## BROWNSTONES @ THORNTON PARK SUBDIVISION

**Applicant's Request:** The applicant proposes to replat a vacant residential property as part of construction of a new 28-unit 3-story townhouse development. The property is located in the Thornton Park neighborhood.

**Staff Recommendation:** Approval of the Minor Plat, subject to conditions in this staff report.

# PROPOSED PLAT

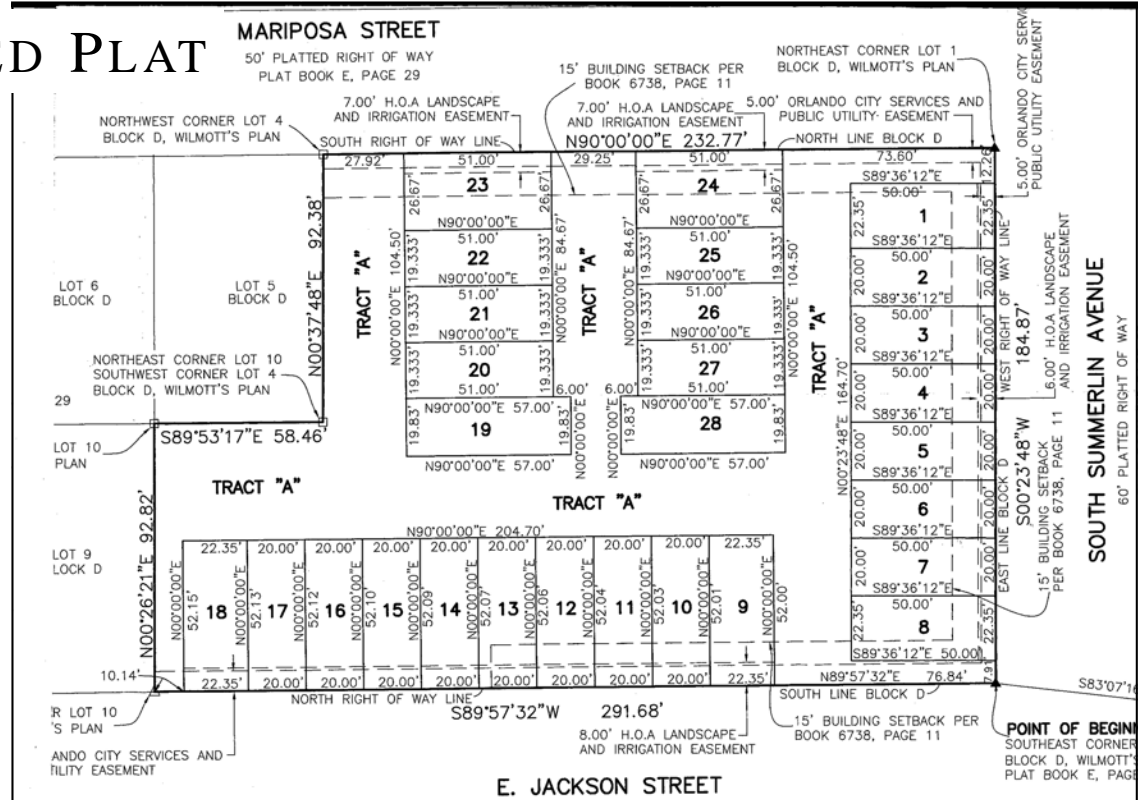
**Legal Affairs** - Notes 4 and 5 to be removed. They reference the DRI and Zoning which are recorded in the public records and not required to be shown on the plat. Thus the "NOTICE"

**City Addressing** - The Plat has been reviewed by Engineering Records, and the plat name has been approved. However, the following items need to be corrected:

Change "SOUTH SUMMERLIN AVENUE" to "S SUMMERLIN AVE" (no period after the S) and "E. JACKSON STREET" to "E JACKSON STREET" (no period after the E) and "S. EOLA DRIVE" TO "S EOLA DRIVE" (no period after the S). This helps denote between a direction that is actually part of the street name and one that is used as a directional indicator.
